HISTORIC AND DESIGN REVIEW COMMISSION

HDRC CASE NO: 2021-026
ADDRESS: 334 BURLESON ST
LEGAL DESCRIPTION: NCB 519 BLK 24 LOT E 42 FT OF N 134.09 FT OF 8
ZONING: IDZ-1, H
CITY COUNCIL DIST.: 2
DISTRICT: Dignowity Hill Historic District
APPLICANT: cesar sosa/5 ELEMENTS INTERNATIONAL LLC
OWNER: Ruben Lara/5 ELEMENTS INTERNATIONAL LLC
TYPE OF WORK: Construction of a two-story, single-family residential structure
APPLICATION RECEIVED: May 19, 2021
60-DAY REVIEW: Not applicable due to City Council Emergency Orders
CASE MANAGER: Edward Hall

The applicant is requesting a Certificate of Appropriateness for approval to construct a 2-story residential structure on the vacant lot at 334 Burleson, located within the Dignowity Hill Historic District.

Historic and Design Review Commission
Design Review Committee Report

1 SITE PLAN

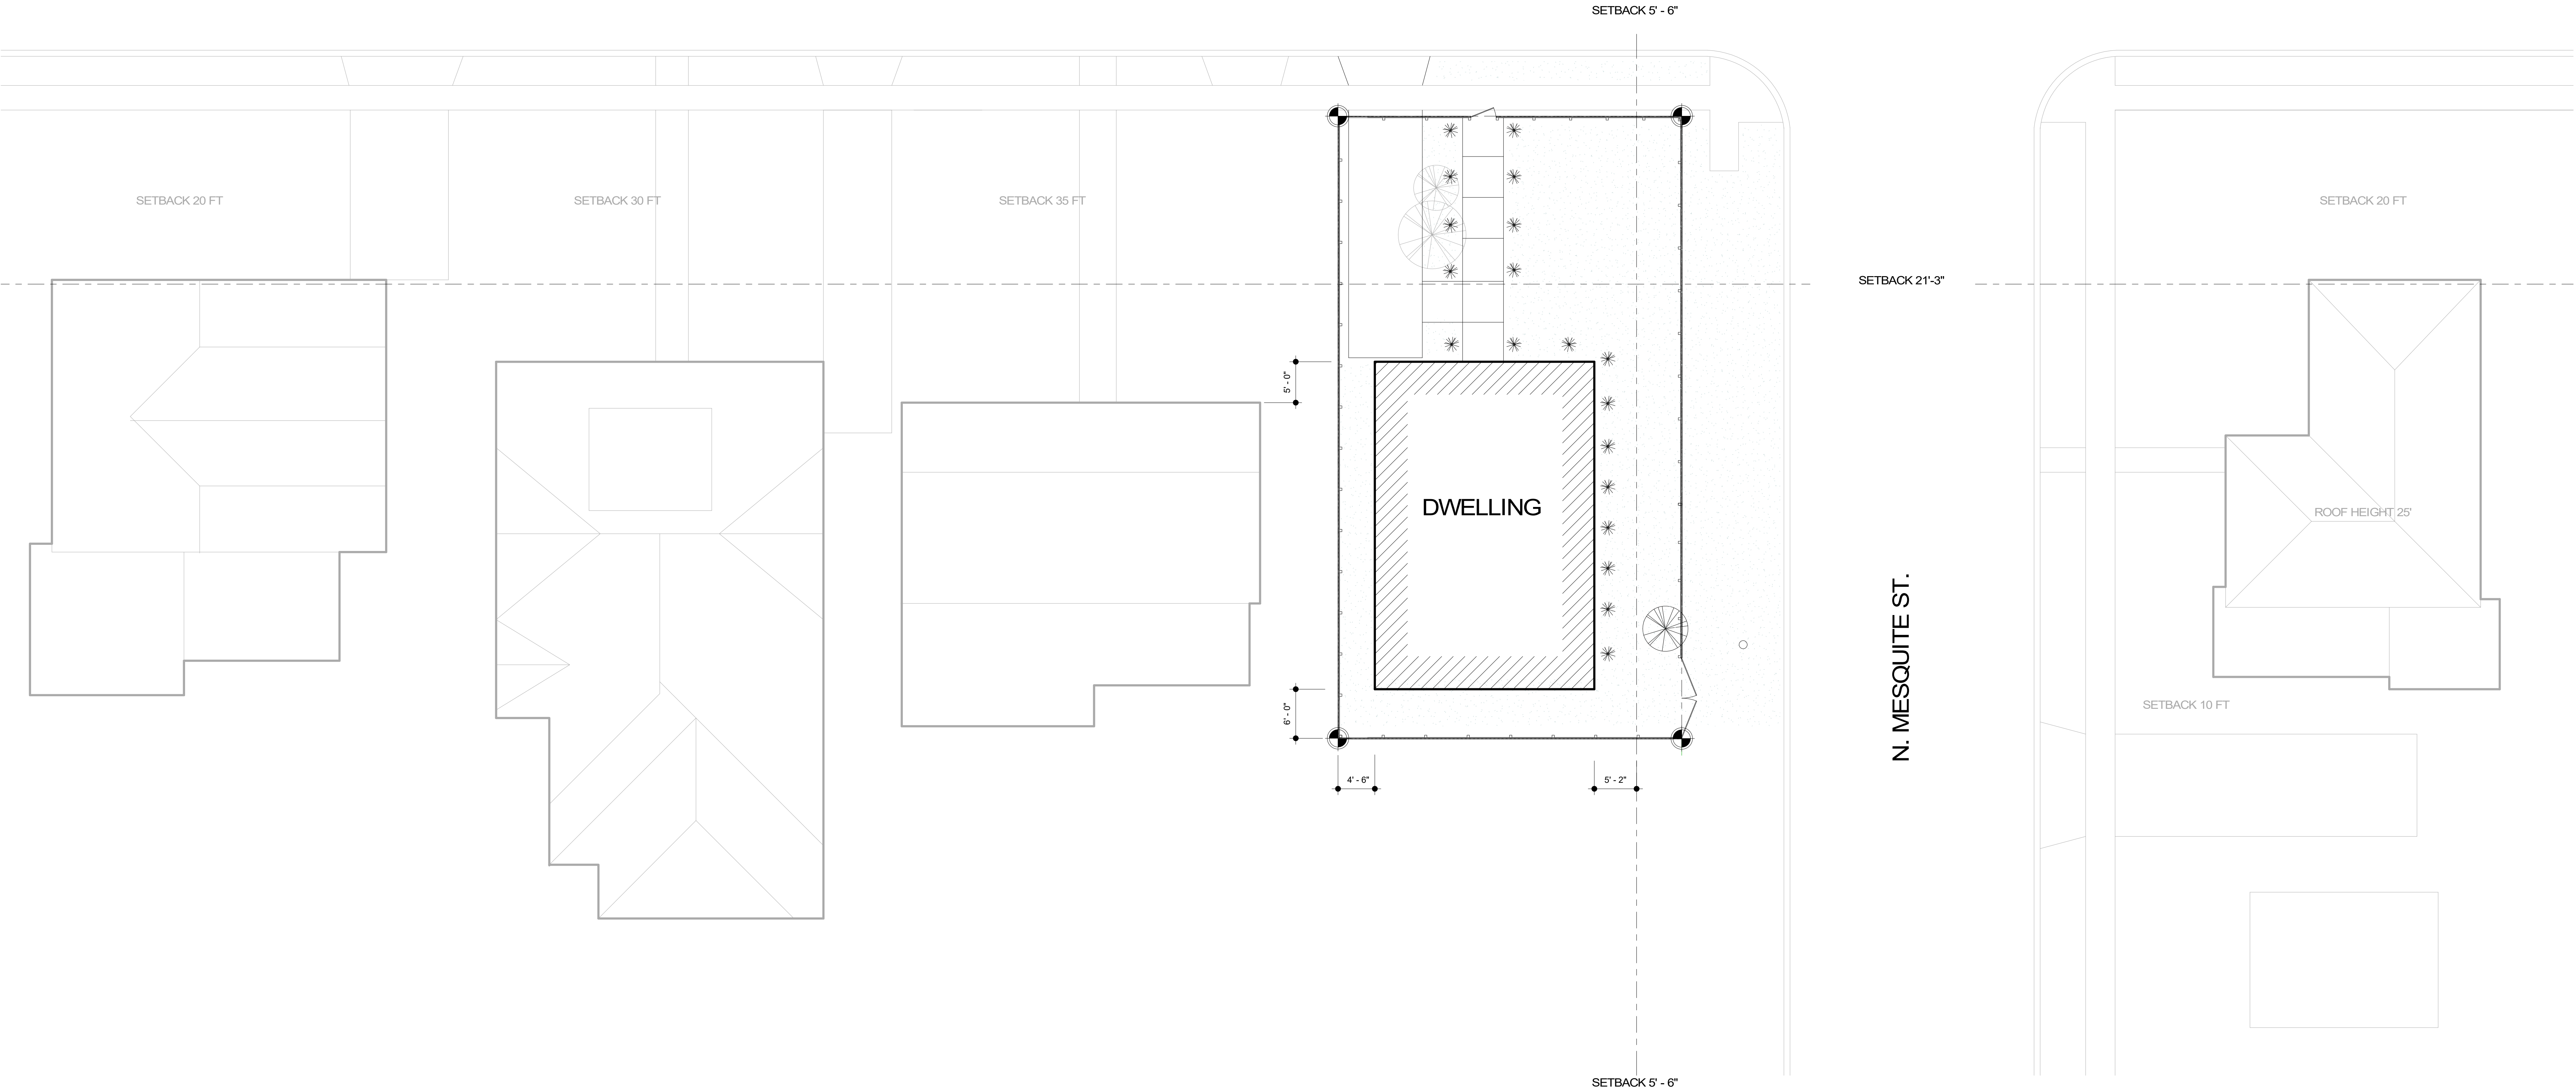
- f. **SETBACKS & ORIENTATION** – The applicant has proposed two setbacks, based on the location of the proposed driveway. Generally, staff finds that shifting the proposed new construction to the right (east) would accommodate a deeper setback, consistent with the setback at 334 Burleson, and would accommodate the driveway to be located on Burleson.

- p. **DRIVEWAY** – The applicant has proposed two driveway options. One option locates the driveway on Burleson while the other locates it to the south of the proposed new construction on N Mesquite. Staff finds the second option, to locate the driveway to the south of the new construction to be most appropriate as the first option would result in a driveway that intersects with the house and creates a front yard parking condition.

- i. That the applicant shift the proposed new construction to the east, to accommodate a deeper setback and a driveway on Burleson, as noted in finding f. An increased setback may reduce the perceived height and massing as noted in finding g.

1 NORTH ELEVATION
SCALE 1/4" = 1'-0"

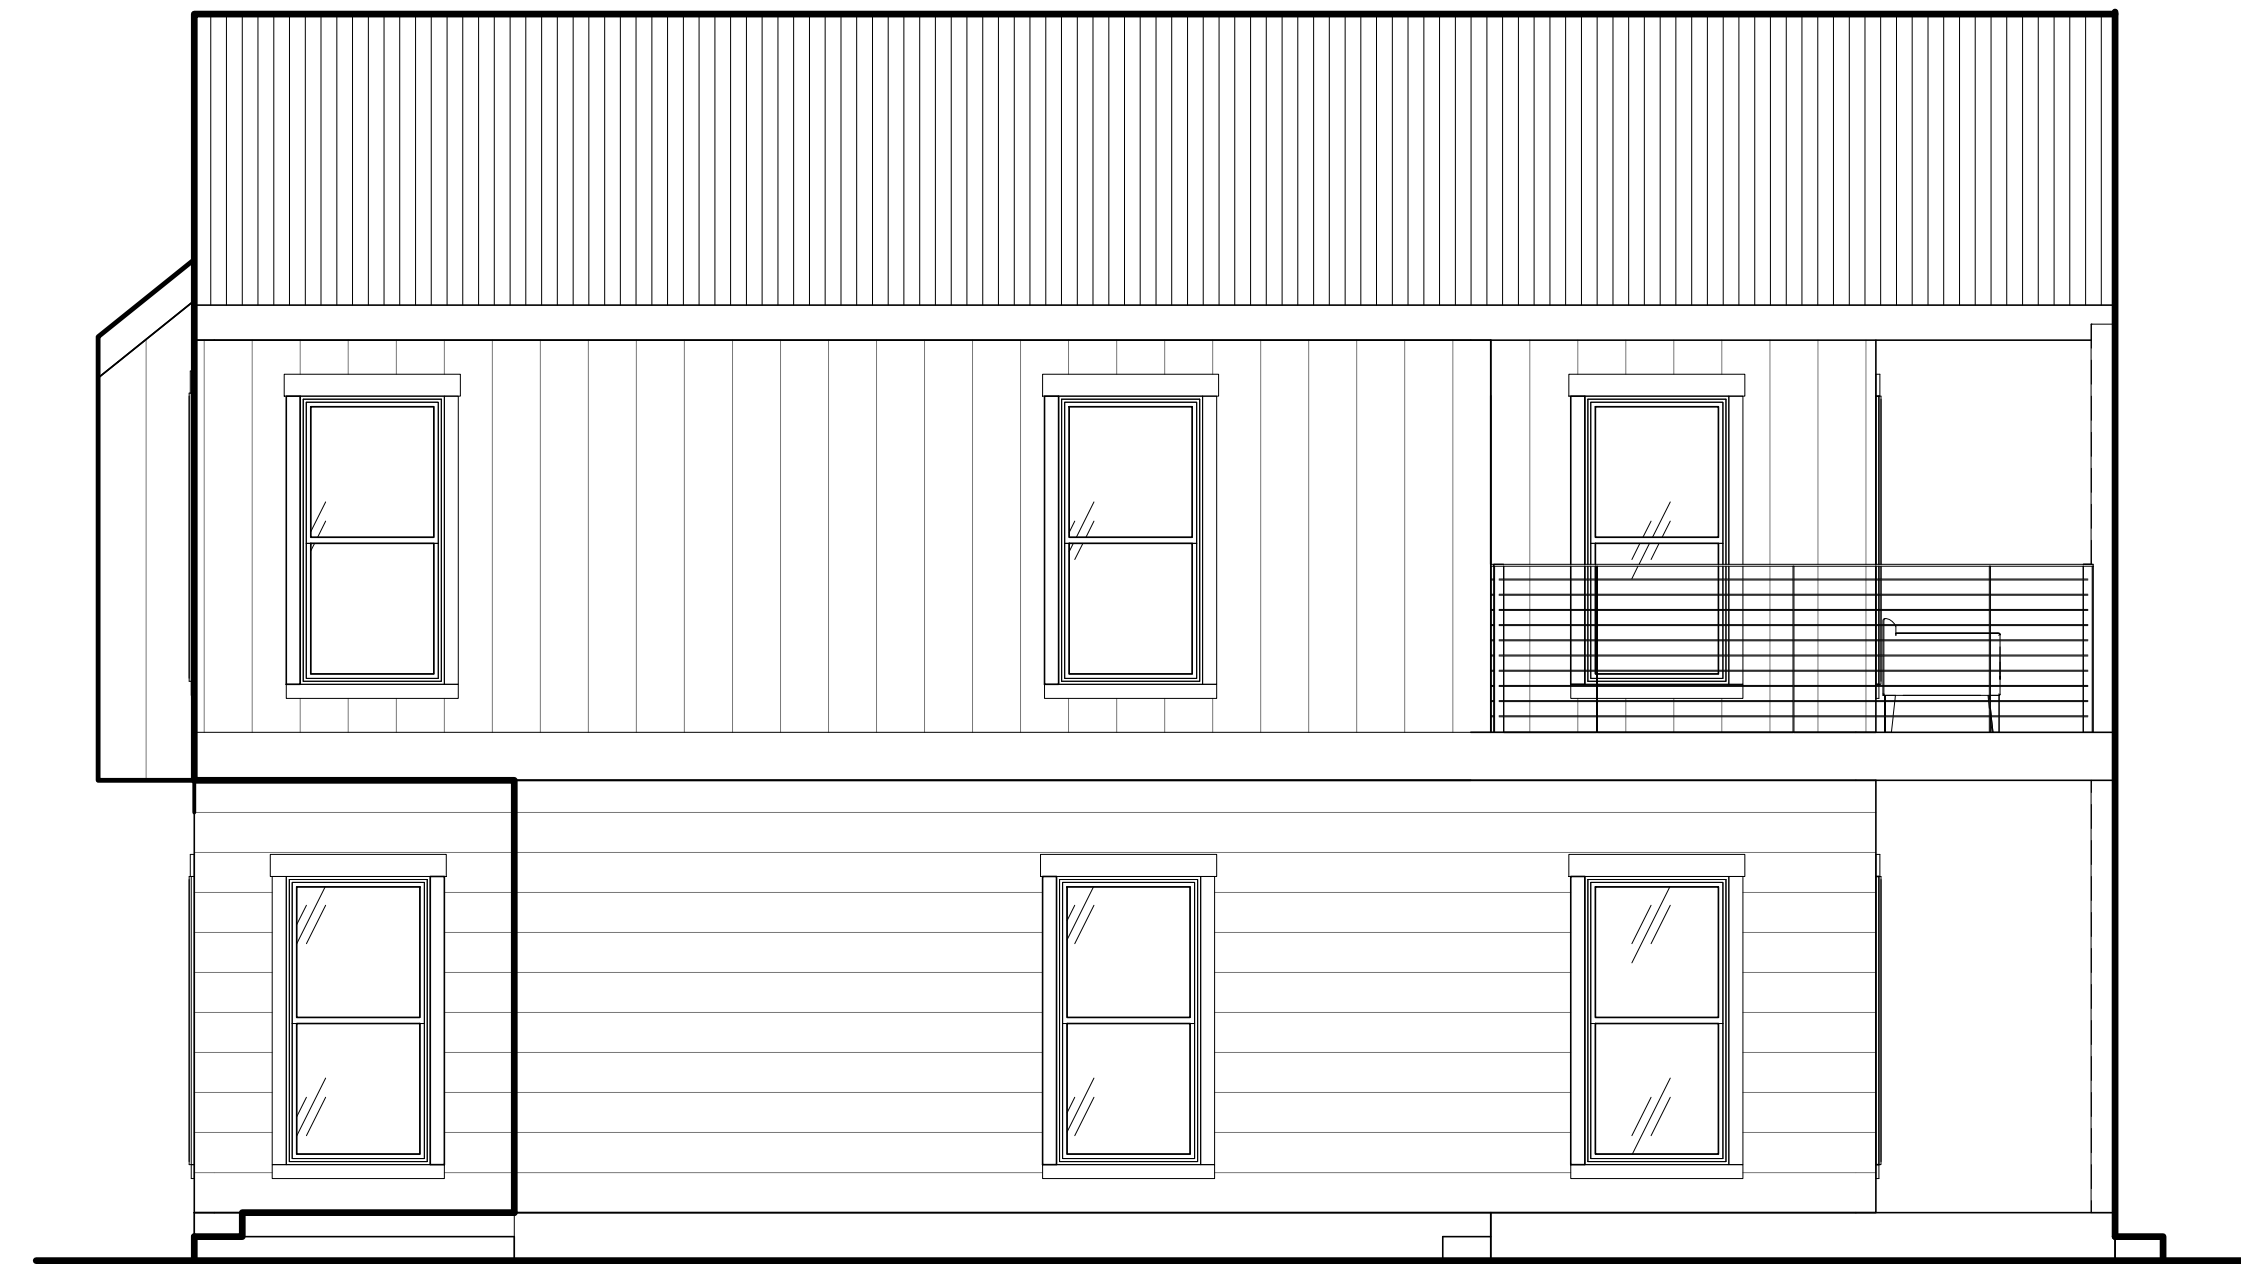
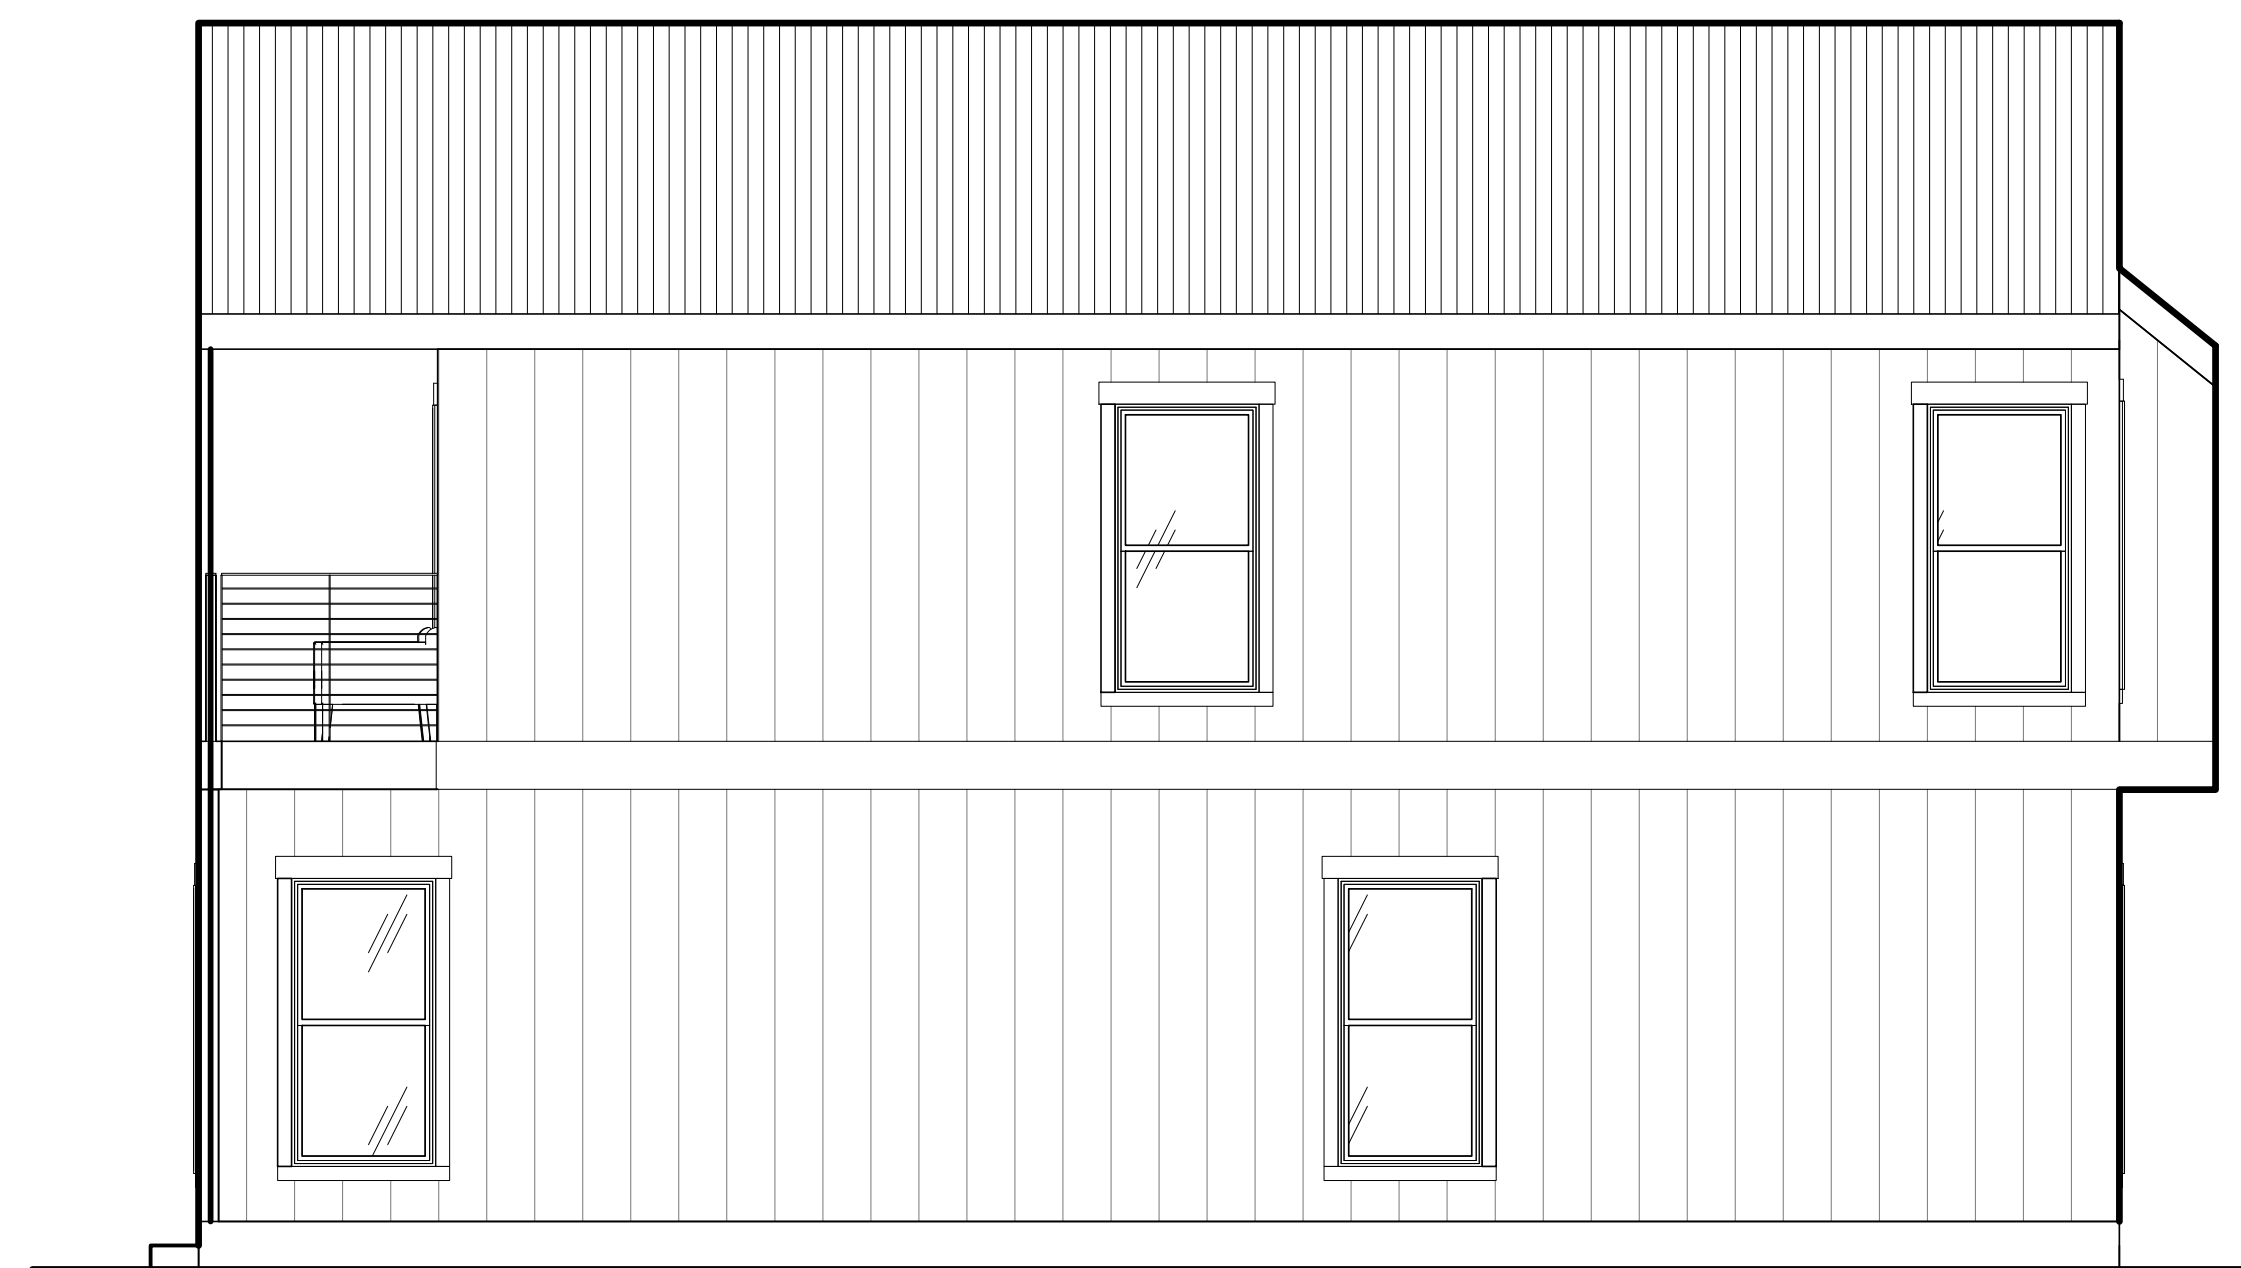
- g. **SCALE & MASS** – Per the Guidelines for New Construction 2.A.i., a height and massing similar to historic structures in the vicinity of the proposed new construction should be used. In residential districts, the height and scale of new construction should not exceed that of the majority of historic buildings by more than one-story. As noted in finding b, this block of Burleson features all one story structures. Generally, staff finds the proposed height to be in excess of what is found historically on the block. An increased front setback may reduce the perceived height and massing in relationship to the 1-story historic structures on the block.

- j. **ROOF FORMS** – The applicant has proposed a front and rear facing gabled roof. While shallower in pitch than gabled roofs found historically within the district, staff finds the proposed roof form to be generally consistent with the Guidelines; however, staff finds that traditional elements such as deeper roof overhangs and deeper eaves should be incorporated into the proposed roof form.

- k. **WINDOW & DOOR OPENINGS** – The applicant has proposed window and door openings that are generally consistent in size and profile as those found historically within the district, and consistent with the Guidelines. Staff finds that the applicant should incorporate window groupings and fenestration patterns that relate to those found historically within the district.

- o. **ARCHITECTURAL DETAILS** – As noted in the findings above, staff finds that the proposed fenestration should be amended to feature window openings and grouping patterns that are consistent with those found historically within the district. As proposed, window openings feature locations that are atypical of those found historically within the district.

- ii. That the applicant reduce the proposed massing, or increase the front setback to reduce the perceived massing in relationship to the historic structures on Burleson.

- iii. That the applicant incorporate window groupings and fenestration patterns that relate to those found historically within the district, as noted in finding k.

- vii. That traditional roof elements such as deeper roof overhangs and deeper eaves should be incorporated into the proposed roof form, as noted in finding j.
